# Draft CERC (Terms and Conditions of Tariff) Regulations, 2024

# Suggestions on behalf of NLDC/RLDCs

15<sup>th</sup> Feb 2024

## Deduction of RoE on account of non-availability of FGMO (Para-30(3)(i))

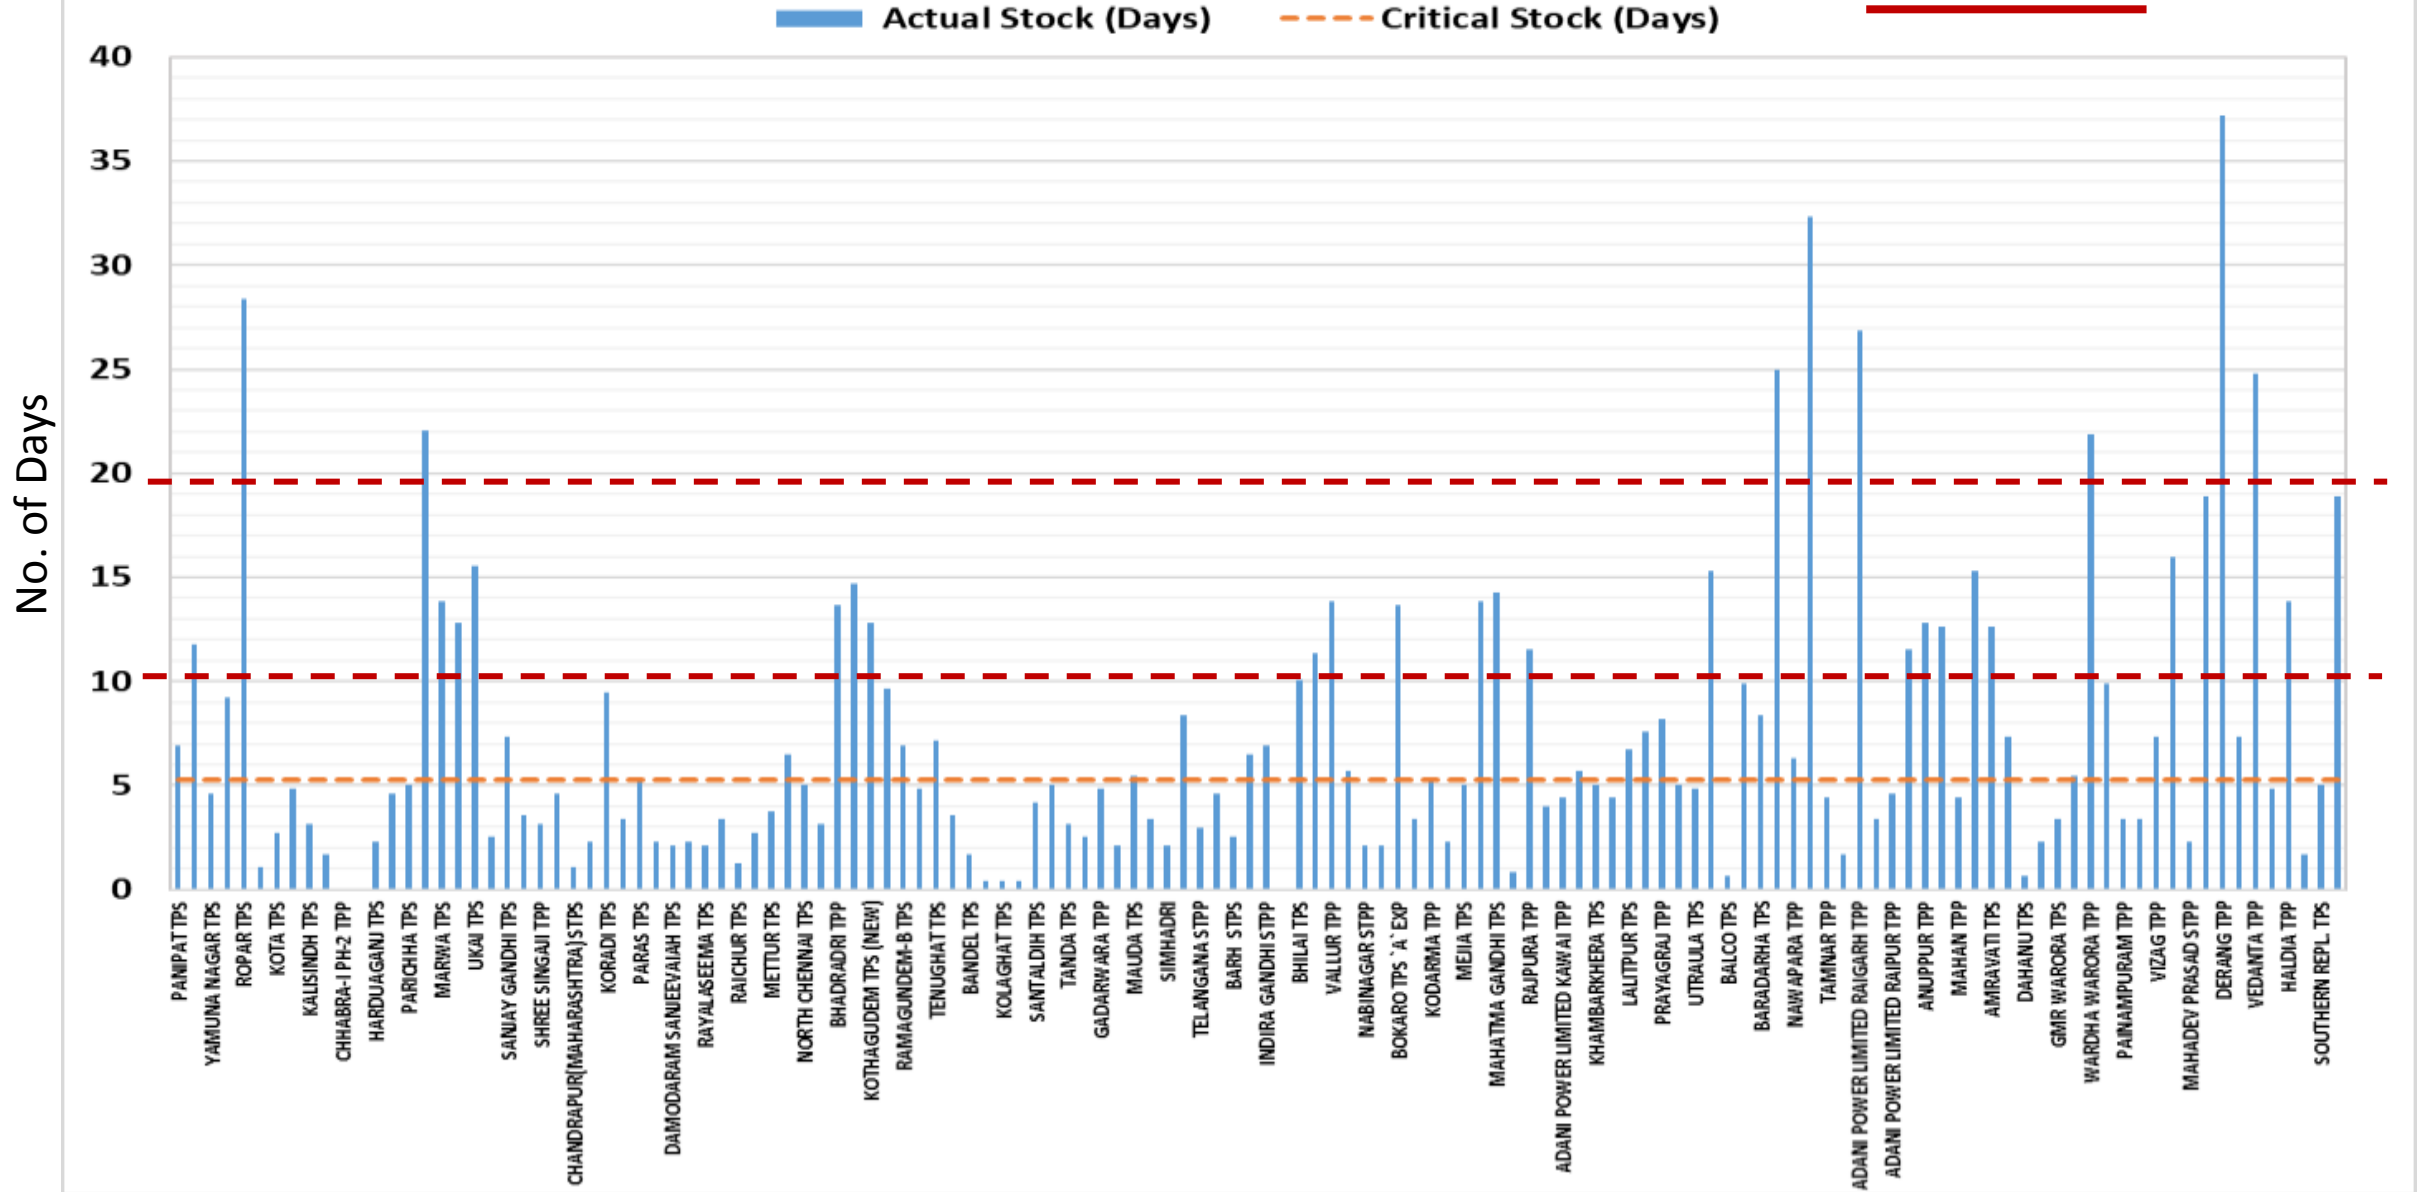
- As per the draft regulation in case of lacking of functional FGMO a new station would get higher amount than an old station, which may not be logical. As per Clause 30.3-(1) & (2) of draft regulation -

- FGMO is a mandated service under IEGC hence, incentivizing only Section 62 generator may have negative impact on Section-63, Merchant plants, IPPs.
  - In existing stations lacking functional FGMO should be treated as violation of IEGC similar to other stations, rather than RoE reduction.

- In future market based PRAS is also envisaged. It would put all generators on equal footing.

# Coal Stock (Days) of Non-pithead Domestic coal based Plants

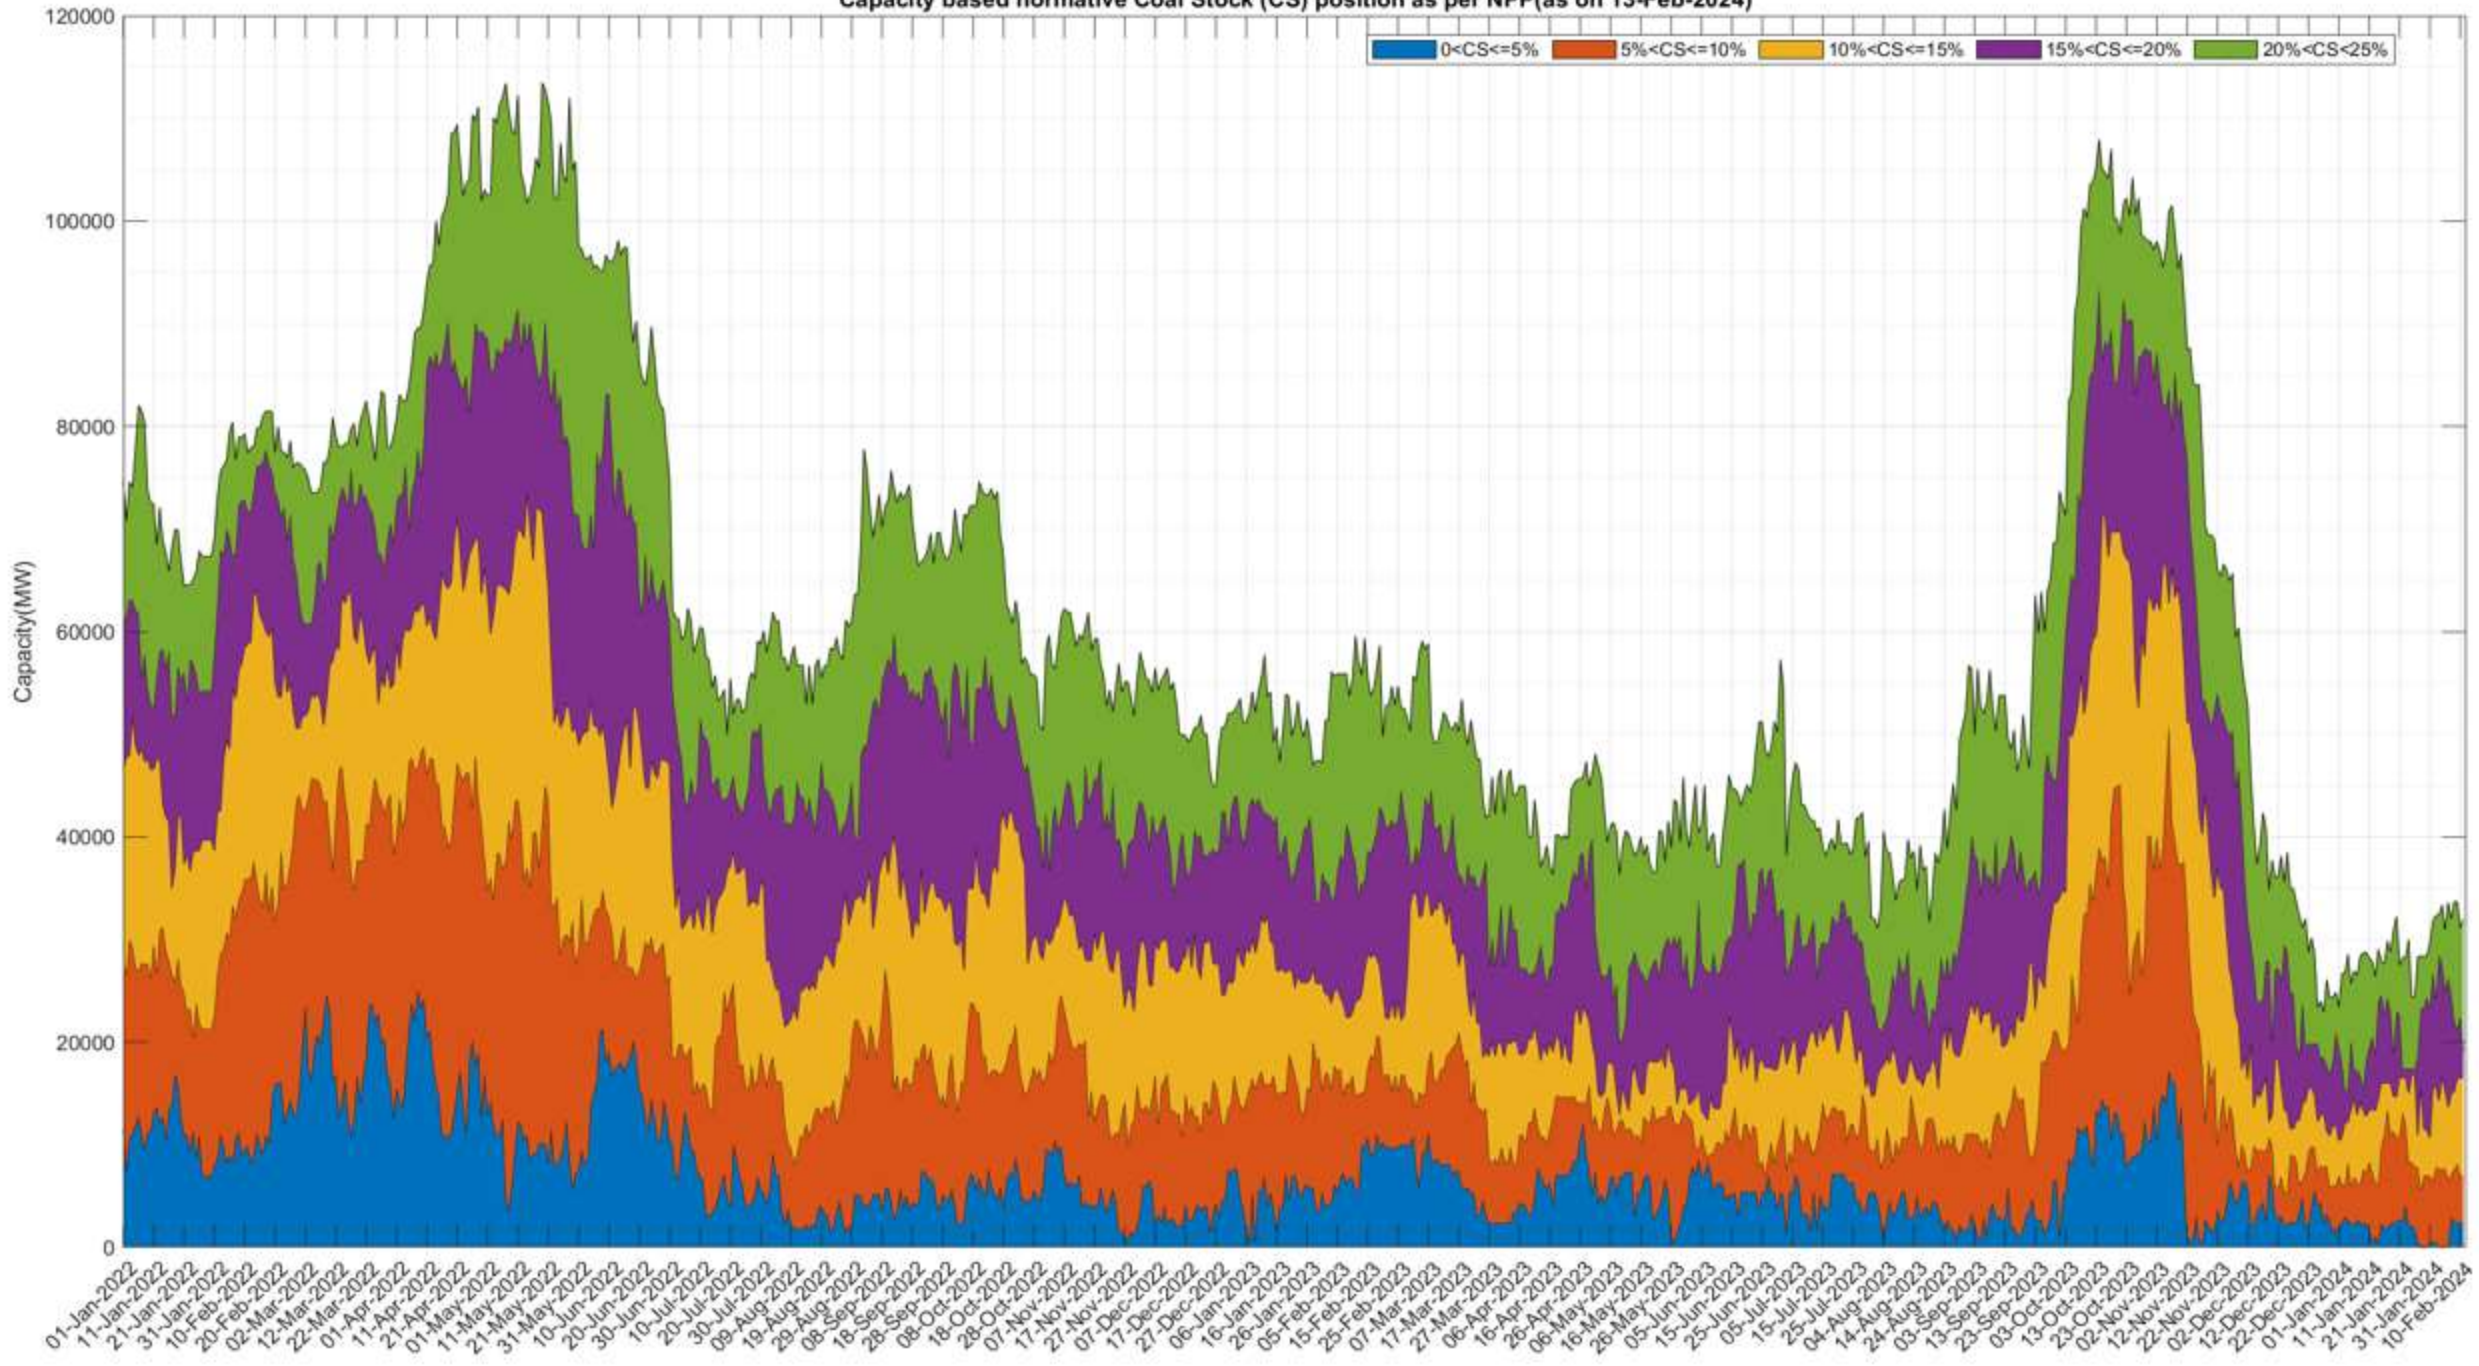
- Working capital factors maintaining normative coal stocks
- Availability calculations are based on day ahead availability (DC) which doesn't capture the on-site fuel stock position.
- During periods of continuous high demand, DC is often revised in real time due to less fuel stock.
- **For maintaining resource adequacy in all time horizon, ensuring adequate fuel stock becomes necessary.**
- Generator availability may be suitably linked to Day ahead availability (one day) and rolling week ahead weekly availability (with suitable weightage) for fixed cost recovery.

# Generation Availability : Peak-Off peak declaration by RLDC (Para 62(3))

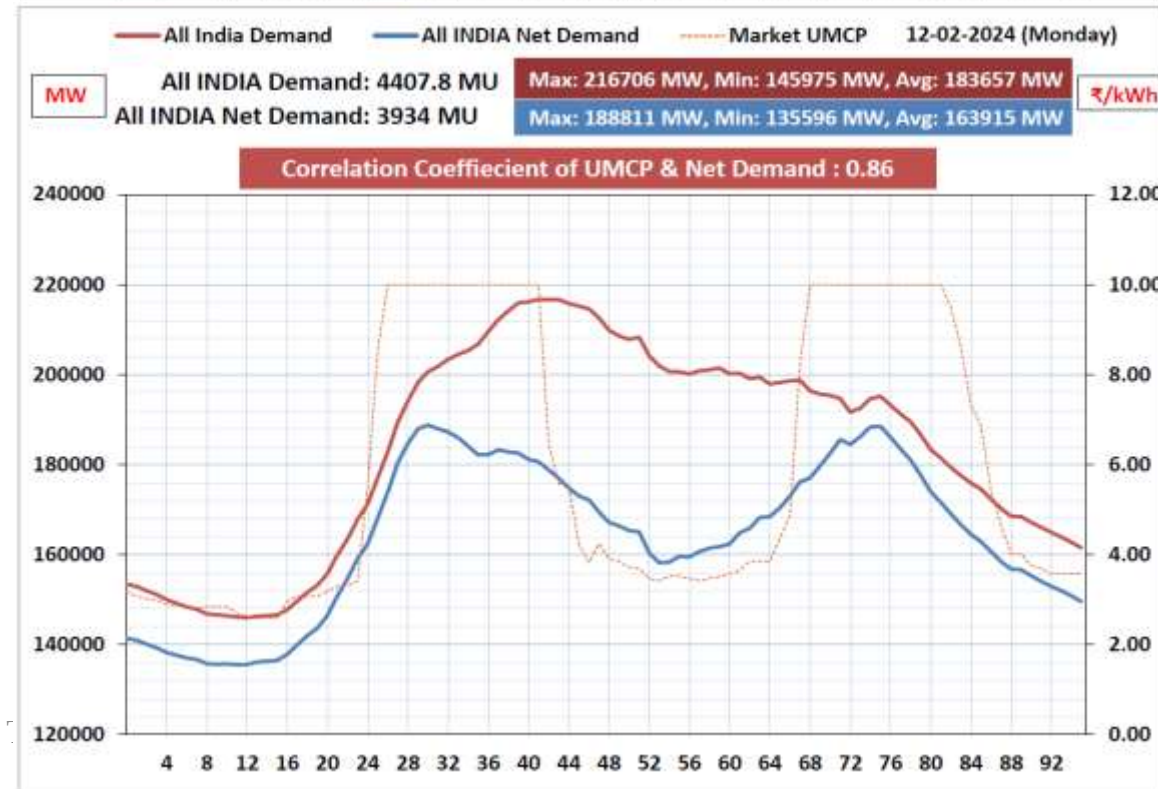
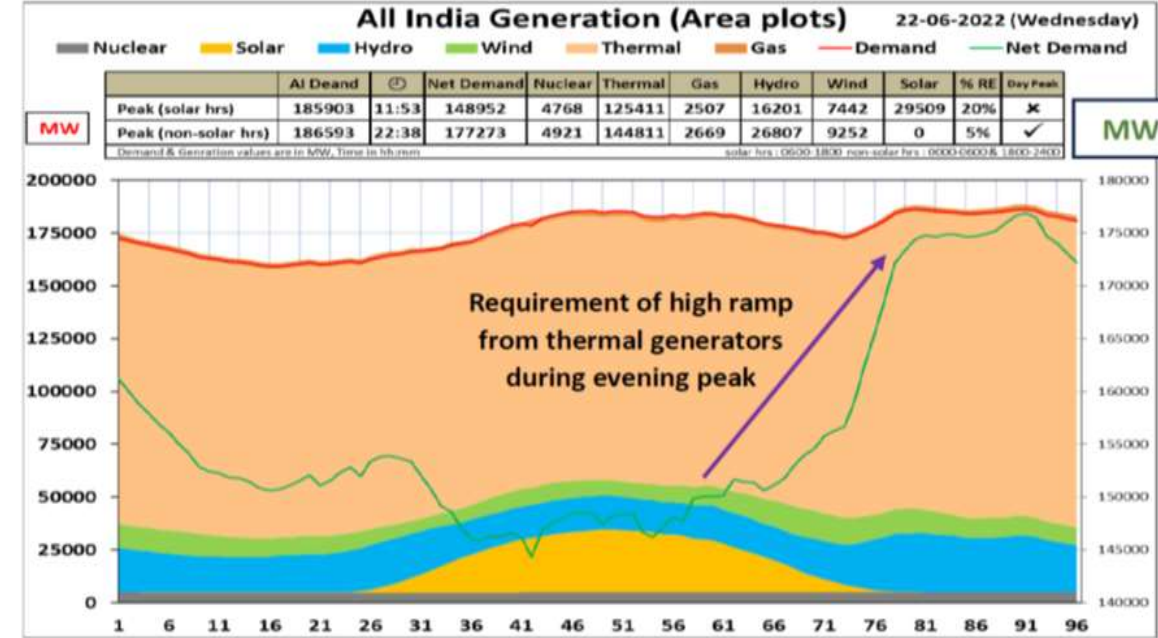
- Peak & Off-Peak hour declaration by RLDCs
- Different peak and off-peak for different regions.
- Less significance of regional boundaries due to national level grid integration.
- **Guidelines for Resource Adequacy Planning Framework for India** mandates DISCOMS to tie-ups to meet estimated requirement of their **contribution towards meeting coincident national peak.**
- Peak and Off-Peak declaration of NLDC should be considered based on All India peak Net Load.
